From : Tim Caswell, Studio Electronics 12-19-94

mods to X99 tube circuit board to reduce
hum & noise in clean channel.

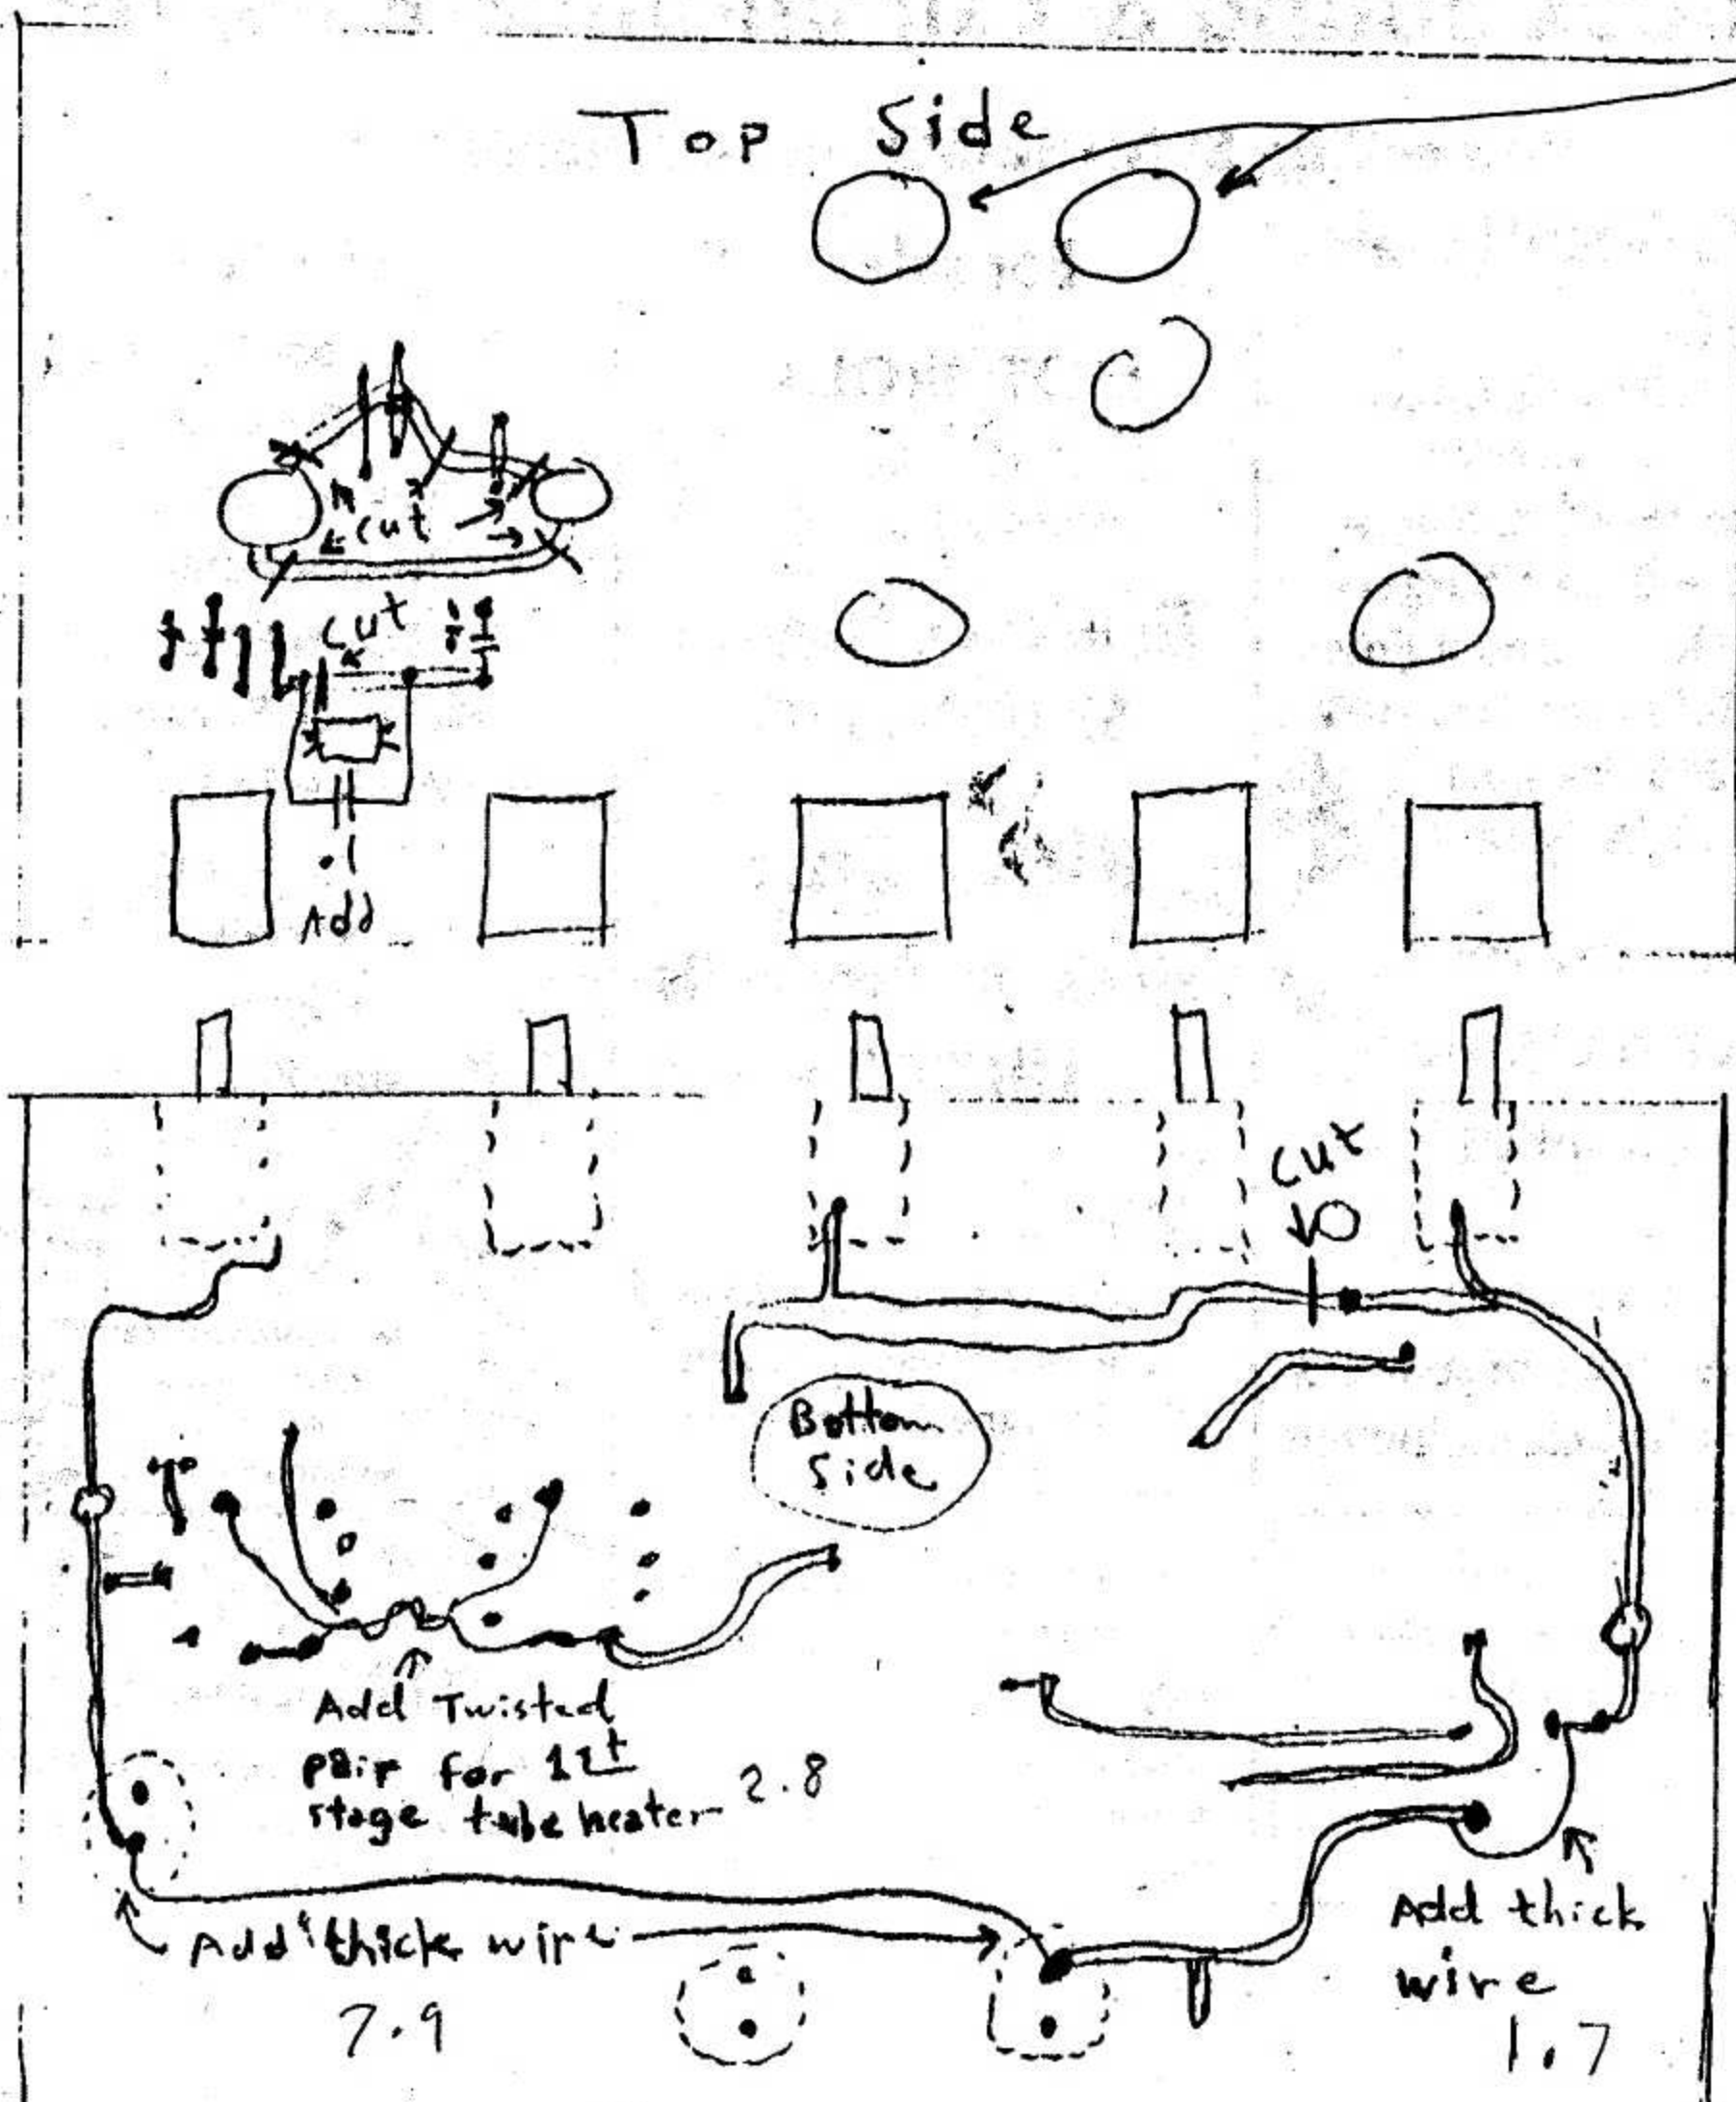
optional -
replace filter
caps with
larger values
100 - 150 μF

Add Twisted
pair for 12^t
stage tube heater - 2.8
Add thick wire
7.9

Add thick
wire
1.7
